Access Compliance Report

Public Rights-of-Way

(Curb Ramps)

Intersection ID: 14442	Main Street: N_SHARON_AMITY_RD	Cross Street: CENTRAL_AV	Location: SE
ADA ID: 648271A3C764	Ramp Type: Perp	Initial Pass/Fail: Fail	Overall Compliance: No
Severity Score: 22.5			
Codes/Mitigation Info/Possible Solution		Field Measurements/Component Compliance

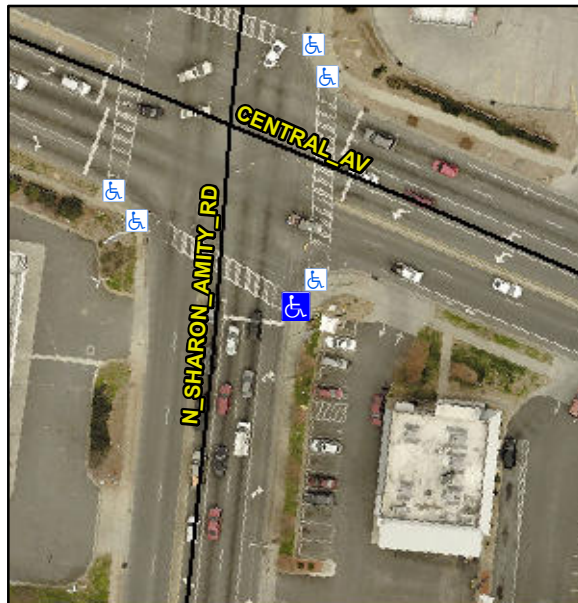
Not Found, R304.5.1, R304.2.2, R304.5.3

Compliance	Description	Data	Compliance	Description	Data
N/A	Ramp Length (in)	60.5	No	Ramp Slope (%)	8.6
No	Ramp Width (in)	47.5	No	Ramp XSlope (%)	3.5
N/A	Flare Type LT	N/A	N/A	Flare Type RT	N/A
N/A	Flare Slope LT (%)	N/A	N/A	Flare Slope RT (%)	N/A
N/A	Flare Traversable LT?	N/A	N/A	Flare Traversable RT?	N/A
N/A	Landing Length (in)	N/A	N/A	DWS Provided?	N/A
N/A	Landing Width (in)	N/A	N/A	DWS Contrast?	N/A
N/A	Landing Slope (%)	N/A	N/A	DWS Length (in)	N/A
N/A	Landing X Slope (%)	N/A	N/A	DWS Full Width?	N/A
N/A	Landing Curb? (Y/N)	N/A	N/A	DWS Offset (in)	N/A
N/A	Shared Landing?	N/A			
N/A	Gutter Ponding?	N/A	N/A	Gutter Slope (%)	N/A
N/A	Gutter Lip Ht (in)	N/A	N/A	Gutter X Slope (%)	N/A
N/A	Painted X Walk1?	Yes	N/A	Painted X Walk2?	N/A
	X Walk 1 Direction	To NW		X Walk 2 Direction	N/A
N/A	X Walk 1 Width (in)	114.0	N/A	X Walk 2 Width (in)	N/A
	X Walk 1 Slope (%)	2.5		X Walk 2 Slope (%)	N/A
	X Walk 1 X Slope (%)	2.9		X Walk 2 X Slope (%)	N/A

Remove & Replace Entire Ramp.
